MISCELLANEOUS PAPER GL-86-23

# REVIEW OF RIGID PAVEMENT DESIGN FOR CONCRETE FLOOR SLABS ON GRADE

August 1986

Final Report

Figure 1. Design curves for concrete floor slabs by design index

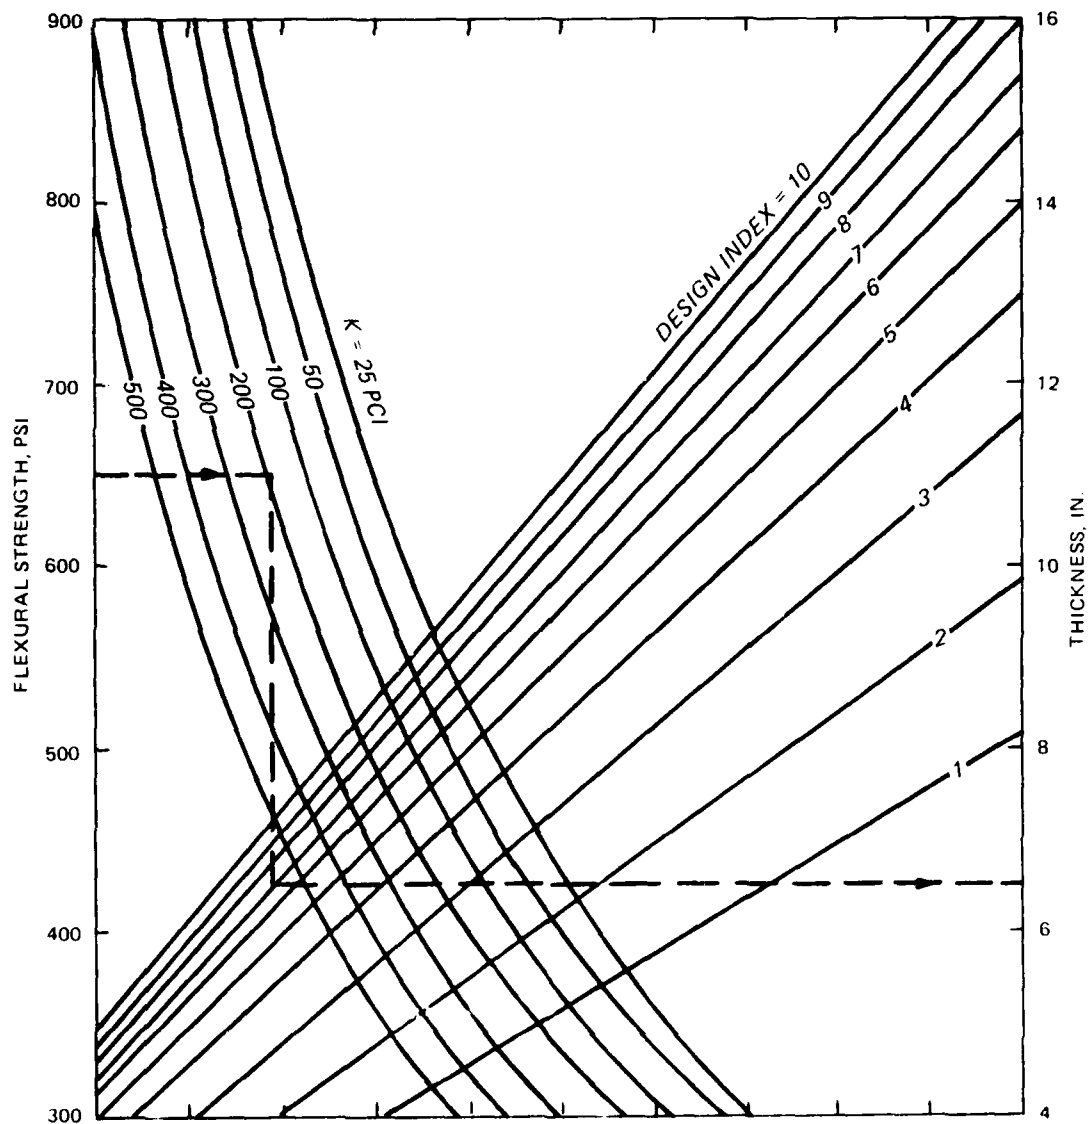
13. The design curves in Figures 1 and 2 of TM 5-809-12 (Headquarters, Department of the Army 1977) are hereby revised by substituting those shown in Figures 1 and 2. An explanation of each figure is as follows:

- a. Figure 1 is the design chart for vehicular parking areas. The design indexes shown are for rigid pavement roads and streets as defined in TM 5-822-2 (Headquarters, Department of the Army, in preparation). The original floor slab design indexes 1 to 4, developed from four typical small forklift traffic mixes, are now represented by design indexes 4, 5, 7, and 8, respectively.
- b. Figure 2 is the design chart for large forklifts having axle loads between 25 and 120 kips. For pavements designed to carry these large loads, vehicles having axle loads less than 25 kips (trucks, cars, buses, and small forklifts) do not significantly affect the required slab thickness. They are therefore ignored for the purpose of thickness determination.

Figure 3. Design thickness for reinforced floor slabs (from TM 5-822-6)

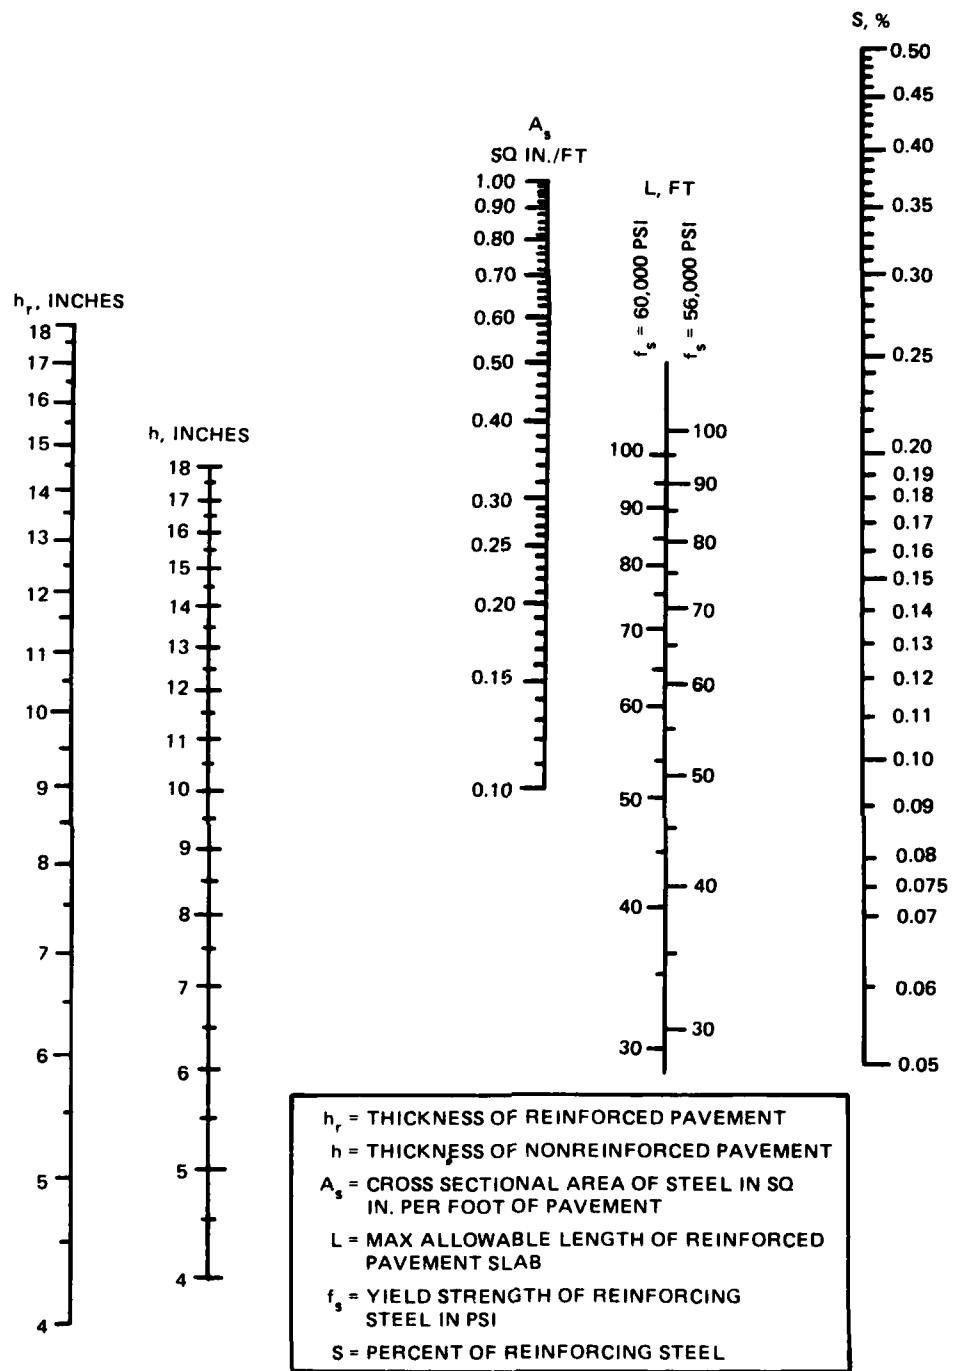
16. For reinforced slabs, thickness reductions for reinforcing steel are now allowed for as little as 0.05 percent steel. The same maximum of 0.5 percent reinforcing steel for thickness reduction is retained. This change is implemented by incorporating the nomograph of the March 1984 draft of TM 5-822-6, (Headquarters, Department of the Army, in preparation). This nomograph is shown in Figure 3.

Figure 4. Design curves for steel-fiber-reinforced concrete floor slabs by design index

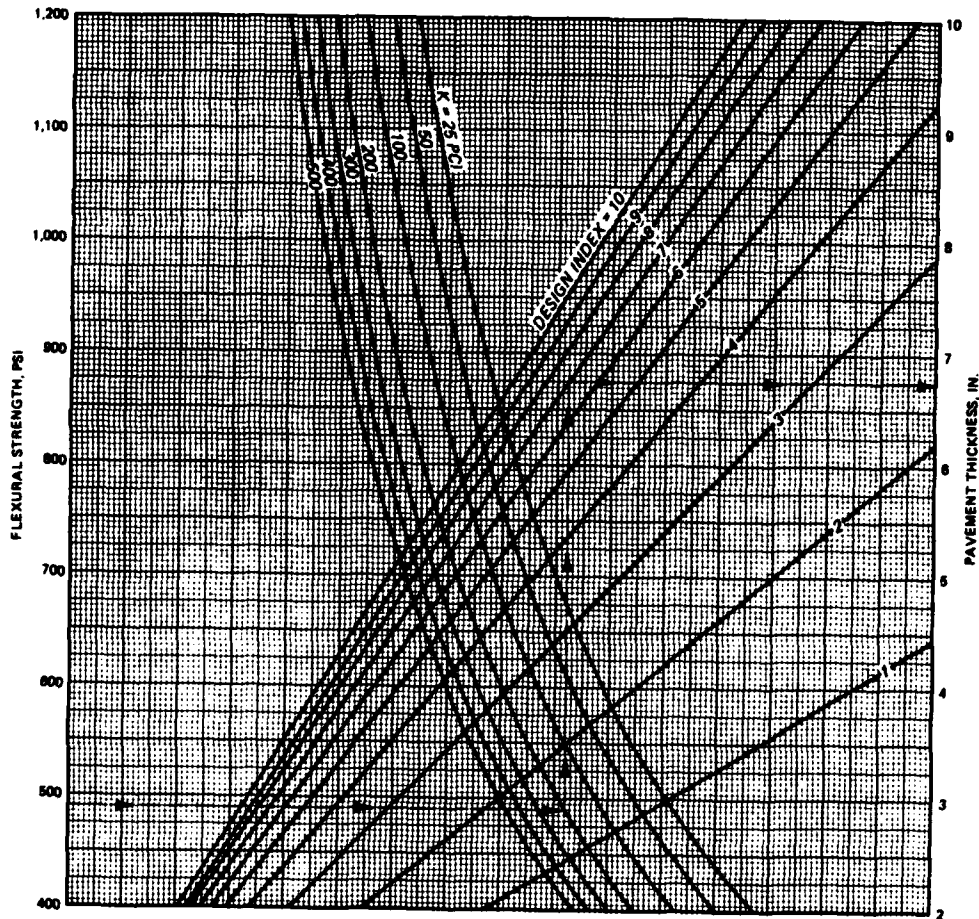
20. The thickness design curves for use with steel-fiber-reinforced concrete slabs are shown in Figures 4 and 5. Deflections are determined from Figure 6 and checked against Figure 7. Note that axle loads less than 25 kips do not produce deflections in excess of those allowed by Figure 6, and therefore do not require a deflection check.
